PERMIT

SEWAGE DISPOSAL SYSTEM

HOWARD COUNTY HEALTH DEPARTMENT

A REPAIR

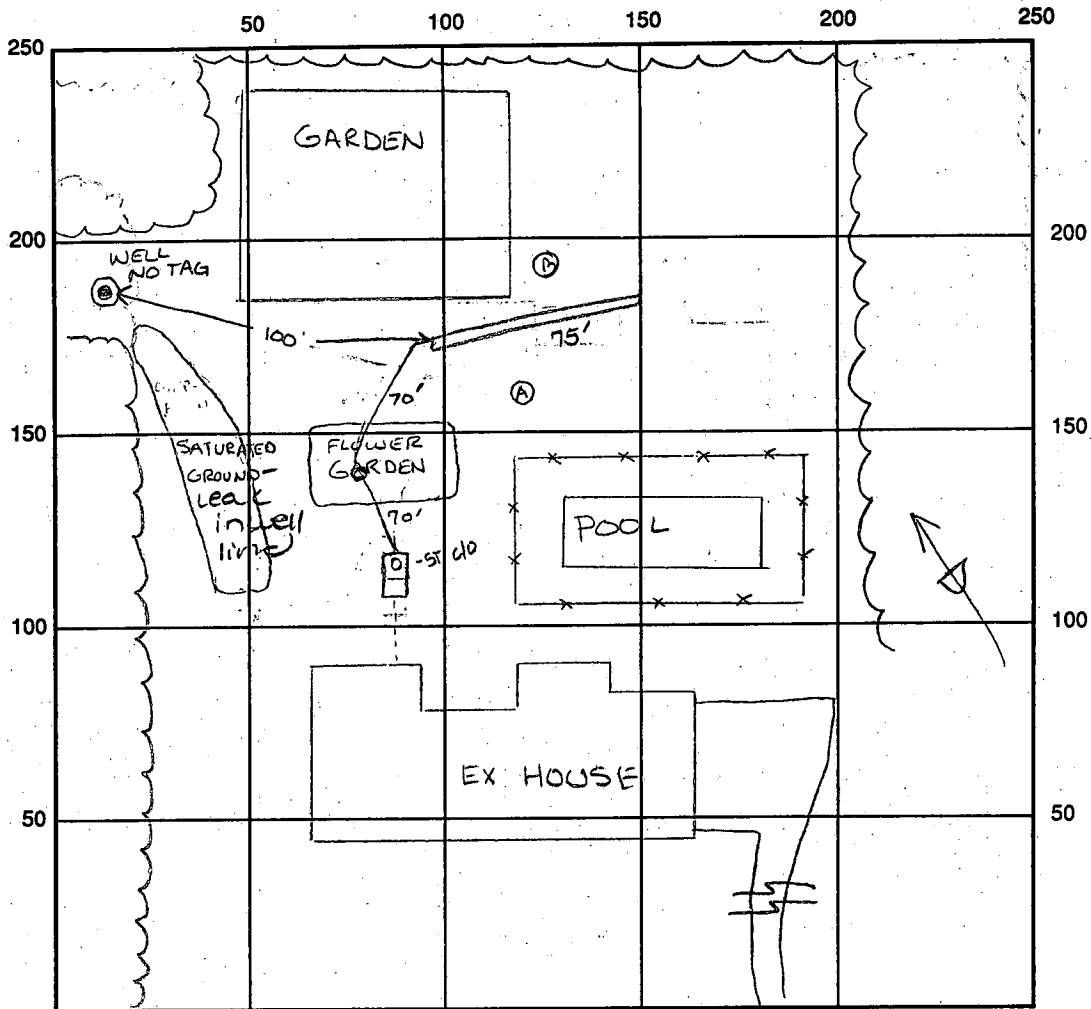
Run a 75' trench inlet at 3' bottom at 8' with 5 foot of stone.

Place trench 100' from existing well and appx. 10' off edge of garden,
run on contour toward the right lot line as seen when facing
the lot from Hipsley Mill Rd. Do not have to use existing drywell.

REMARKS: 9/18/95 OK to store trench and continue. DKS

9/20/95 FINAL - OK to cover all work. DKS
